# Technical Service Bulletin

**MODEL(S) AFFECTED:** Tennant 6600, 6650, 7400, 8200, and 8210 machines (equipped with GM 1.6L gasoline/LP engines)

**SUBJECT:** Replacing a 7 psi radiator cap with a 15 psi radiator cap.

FIG. 1

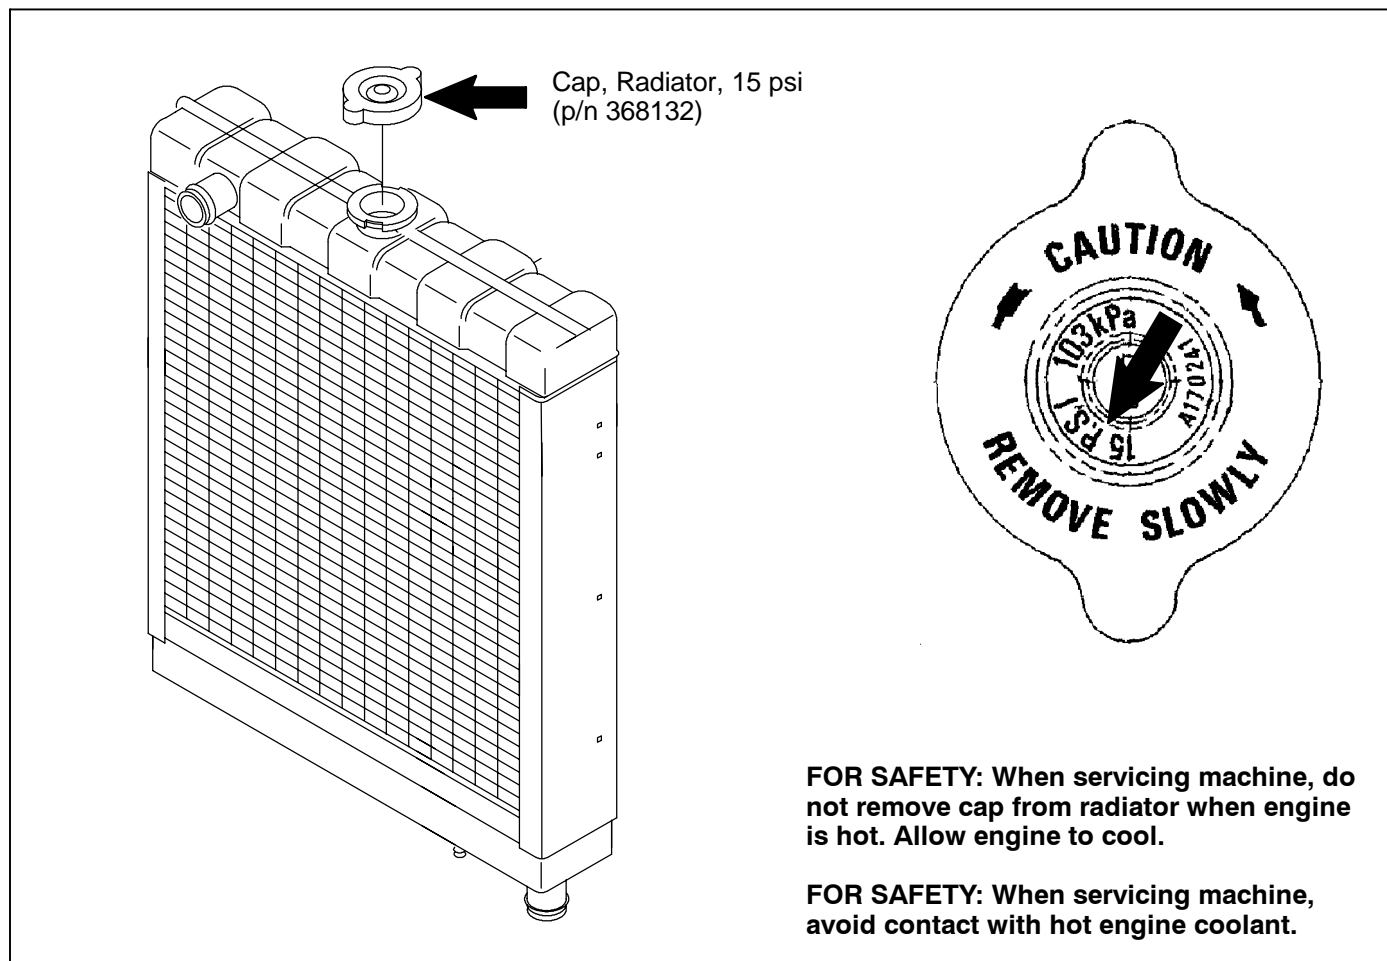
**PURPOSE:** Radiator cap psi rating was increased to improve GM 1.6L engine cooling performance.

**NOTES:** Order Cap, Radiator, 15 psi (p/n 368132).  
Before installing 15 psi radiator cap, pressure test cooling system to 15 psi to ensure there are no leaks in the system.  
If servicing machine that required the cooling system to be drained for repair, refer to TSB 108 for instructions how to correctly purge air from the cooling system.  
Questions, contact the Tennant Customer Service Department at (800) 553-8033 or (763) 513-2850.
